**WEST LINN CITY COUNCIL
FINAL DECISION AND ORDER
FILE NOS. DR-23-01 AND AP-24-01**

**IN THE MATTER OF AN APPEAL OF A CLASS II DESIGN REVIEW AT
1919 & 1949 WILLAMETTE FALLS DRIVE.**

**WEST LINN PLANNING COMMISSION
FINAL DECISION AND ORDER
FILE NO. DR-23-01**

STAFF REPORT FOR THE PLANNING COMMISSION

3 ROOF PLAN + KNAPPS ALLEY ELEVATION
 CONCEPTUAL PLANS + ELEVATIONS

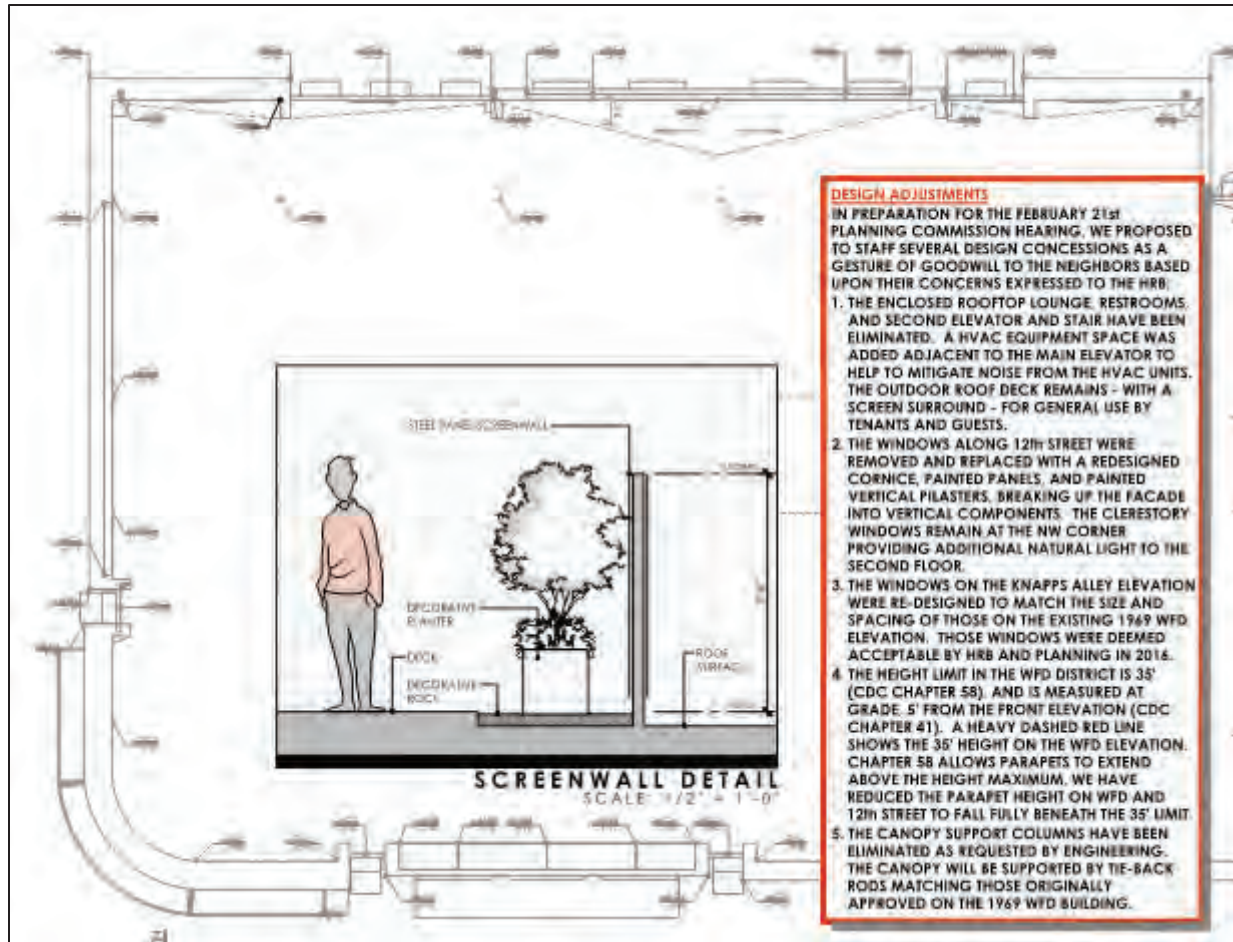
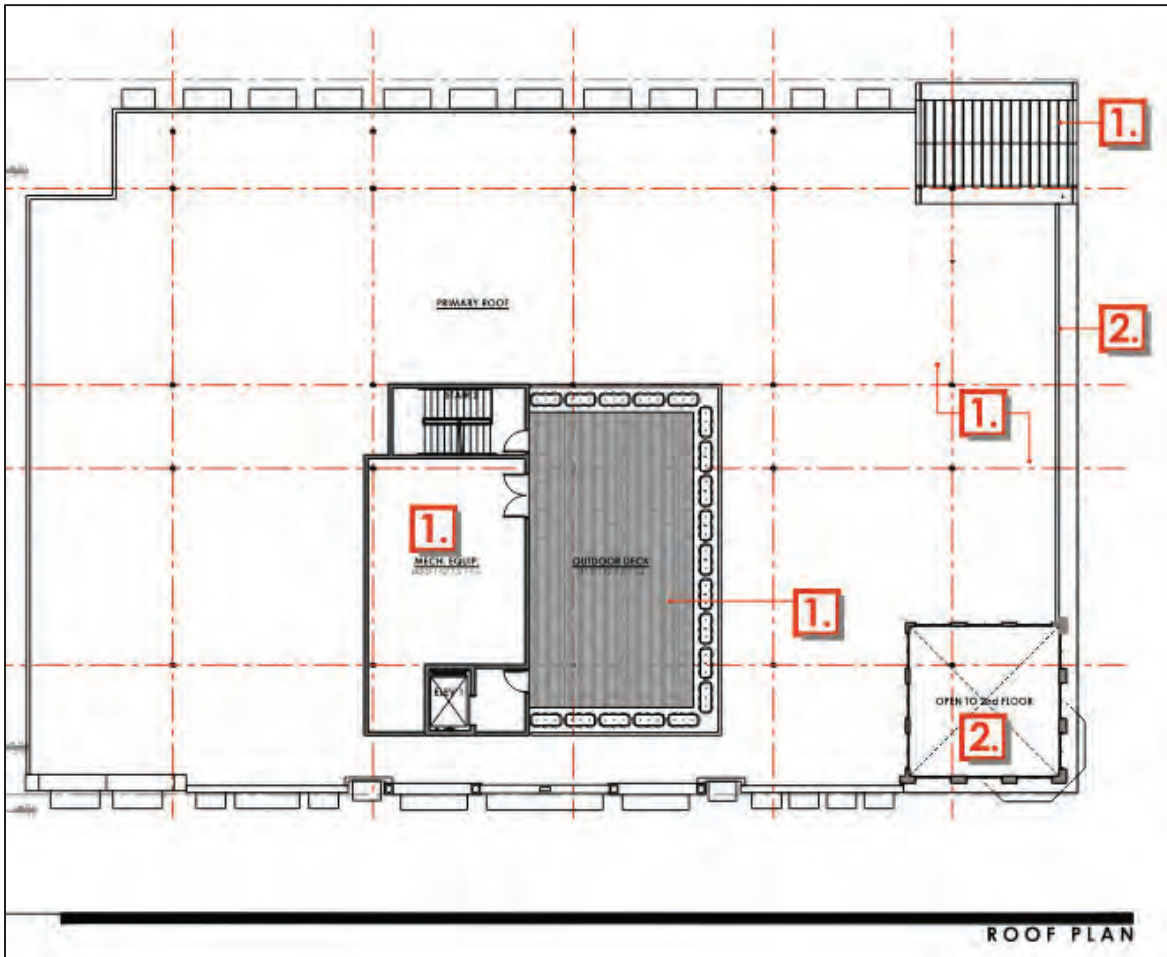
Staff Finding 46: Revised plans submitted on January 29, 20204 (Exhibit PC-1.A) include revised elevations that demonstrate parapet heights and floorplans in compliance with the 35 foot height standard (see Sheets 1 through 4 and Sheet G, prepared for the February 21, 2024 Planning Commission hearing).

Sheet 3 of the same set identifies rooftop improvements that include an unroofed outdoor deck centered in the middle of the rooftop, an elevator, a mechanical equipment area, and a stairwell.

The elevator and stairwell are proposed for rooftop access, and the mechanical equipment shelter is proposed to attenuate noise from HVAC equipment for the structure. As discussed in Staff Finding 4, staff finds these improvements to exempt from the two-story height standard per CDC 41.030 which states *“Projections such as chimneys, spires, domes, elevator shaft housings, towers, aerials, flag poles, and other similar objects not used for human occupancy are not subject to the building height limitations of this code.”* Stairwells and mechanical rooms are similar in purpose and form as an elevator shaft, and are normal and usual parts of commercial structures, and could therefore be reasonably interpreted as falling within the intent and purview of this exemption. Furthermore, as discussed in Staff Finding 22, CDC 55.100.C3 requires the applicant to screen HVAC and other mechanical equipment from view, and the proposed equipment enclosure serves that purpose.

Therefore, height standards are met.

**1 GROUND FLOOR PLAN + WILLAMETTE FALLS DRIVE ELEVATION
CONCEPTUAL PLANS + ELEVATIONS**

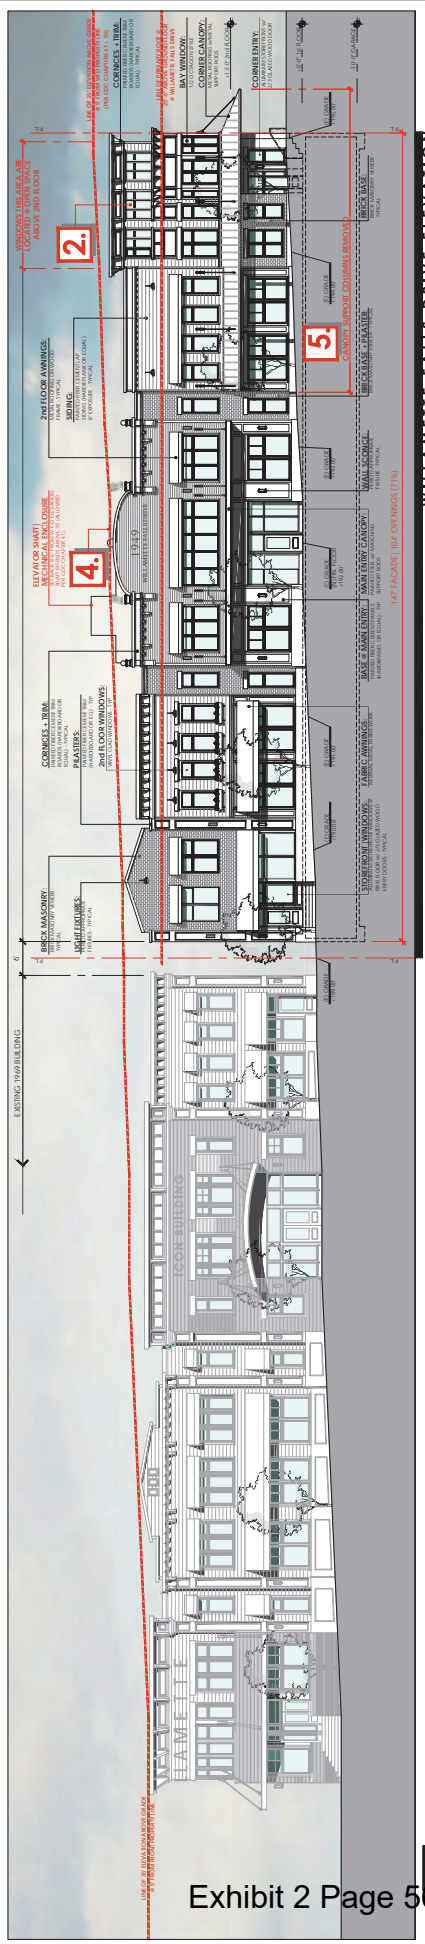
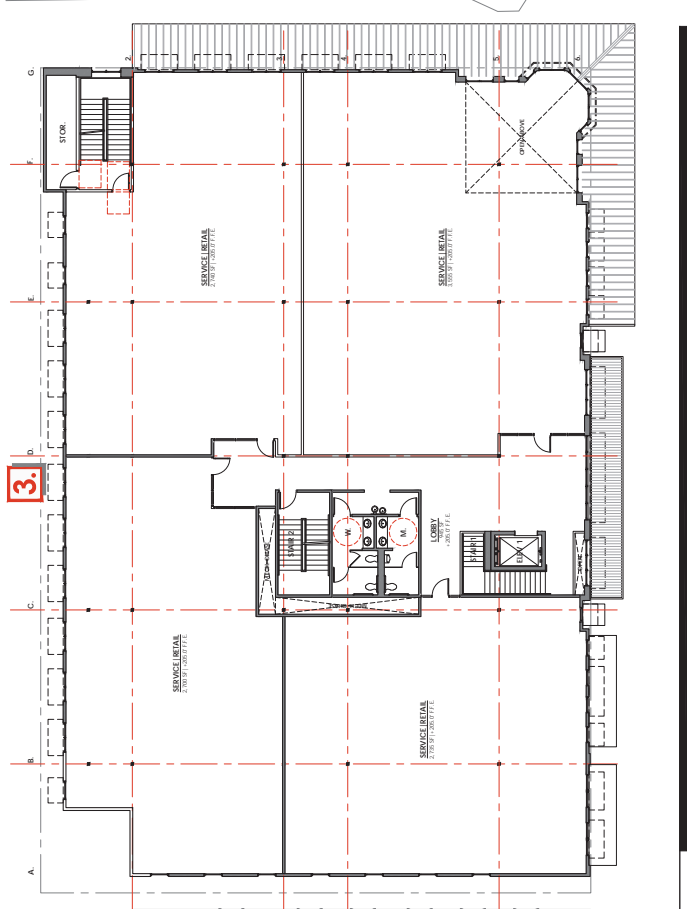
4. (CDC CHAPTER 38), AND IS MEASURED AS 5' FROM THE FRONT ELEVATION (CDC CHAPTER 41). A HEAVY DASHED RED LINE CANOPY WILL BE SUPPORTED BY THE BACK APPROVED ON THE 1969 WFD BUILDING.

5. THE CANOPY SUPPORT COLUMNS HAVE BEEN ELIMINATED AS REQUESTED BY ENGINEERING.

2 SECOND FLOOR PLAN + EAST & 12th STREET ELEVATIONS

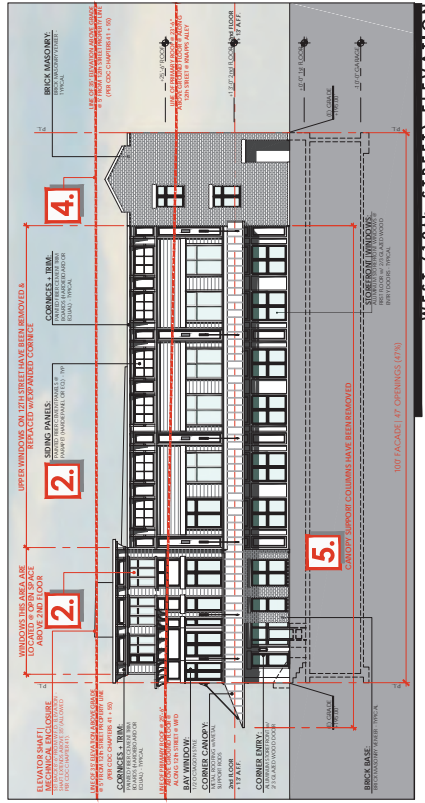
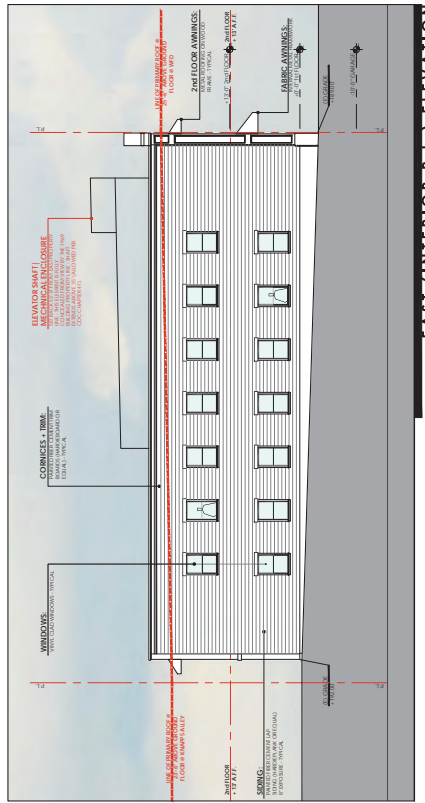
1. THE ENCLOSED ROOFTOP LOUNGE, RESTROOMS, AND MEETING ROOMS WERE ELIMINATED. A HVAC EQUIPMENT SPACE WAS ADDED ADJACENT TO THE MAIN ELEVATOR TO HELP TO MITIGATE NOISE FROM THE HVAC UNITS, TO BE SCREENED BY A SCREEN SURROUND - FOR GENERAL USE BY TENANTS AND GUESTS.

2. THE WINDOWS ALONG 12th STREET WERE REDESIGNED TO INCLUDE CORNICE, PAINTED PANELS, AND PAINTED VERTICAL PLASTERS, BREAKING UP THE FACADE INTO VERTICAL COMPONENTS. THE CERESTORY WAS ELONGATED TO PROVIDE ADDITIONAL NATURAL LIGHT TO THE SECOND FLOOR.

4. (CDC CHAPTER 98), AND IS MEASURED AS 5' FROM THE FRONT ELEVATION (CDC CHAPTER 41). A HEAVY DASHED RED LINE INDICATES THE LOCATION OF THE CANOPY. CHAPTER 98 ALLOWS PARAPETS TO EXTEND ABOVE THE HEIGHT MAXIMUM. WE HAVE REDUCED THE PARAPET HEIGHT ON WFD AS WELL AS THE CANOPY SUPPORT COLUMNS HAVE BEEN ELIMINATED AS REQUESTED BY ENGINEERING. THE CANOPY WILL BE SUPPORTED BY THE BACK APPROVED ON THE 1969 WFD BUILDING.

3 ROOF PLAN + KNAPPS ALLEY ELEVATION

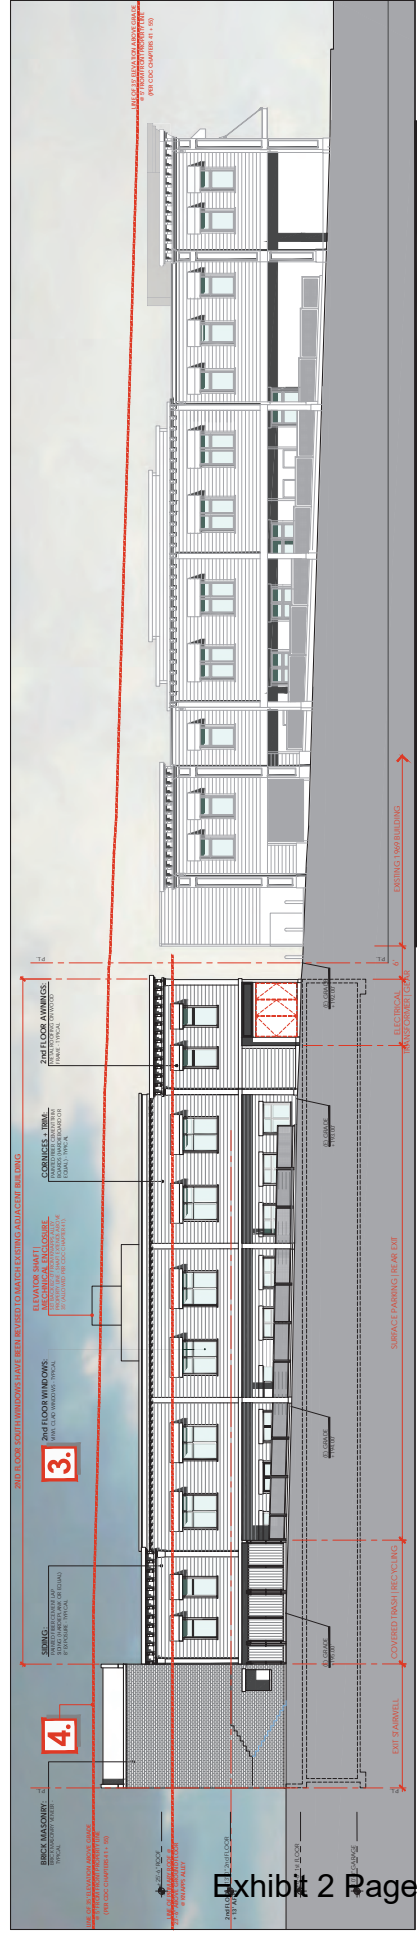
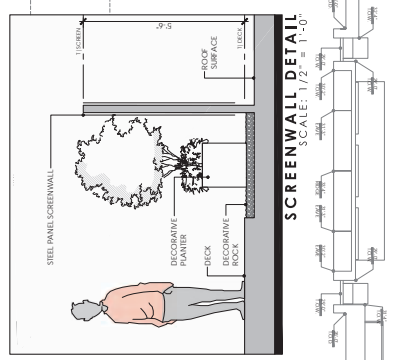
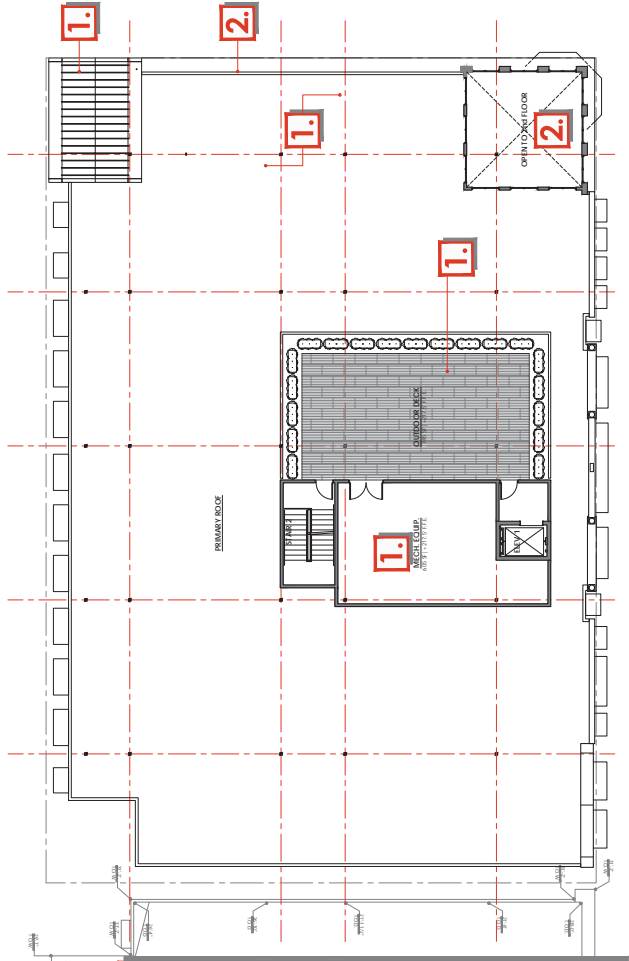
1. THE ENCLOSED ROOFTOP LOUNGE RESTROOMS AND SECOND ELEVATOR AND STAIR HAVE BEEN ELIMINATED. A HVAC EQUIPMENT SPACE WAS ADDED TO THE ROOFTOP LOUNGE TO PROVIDE HELP TO MITIGATE NOISE FROM THE HVAC UNITS. THE OUTDOOR ROOF DECK REMAINS - WITH A SCREEN SURROUND - FOR GENERAL USE BY THE BUILDING OCCUPANTS.

2. THE WINDOWS ALONG 12th STREET WERE REMOVED AND REPLACED WITH A REDESIGNED CORNICE, PAINTED PANELS, AND PAINTED GLAZING. THE CORNICE AND PANELS WILL BE MADE INTO VERTICAL COMPONENTS. THE GLEZTERY WINDOWS REMAIN AT THE NW CORNER PROVIDING ADDITIONAL NATURAL LIGHT TO THE BUILDING.
